VTTX Adapter Board

Version 1.3

July, 2018

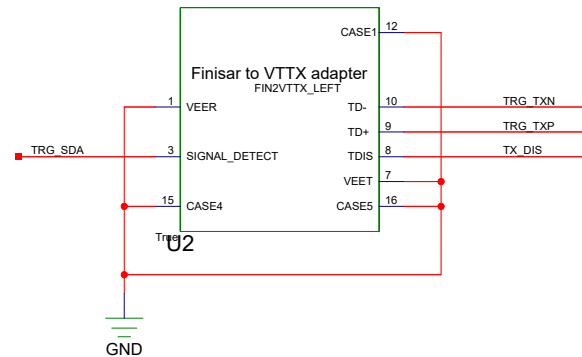
Add pin A to both
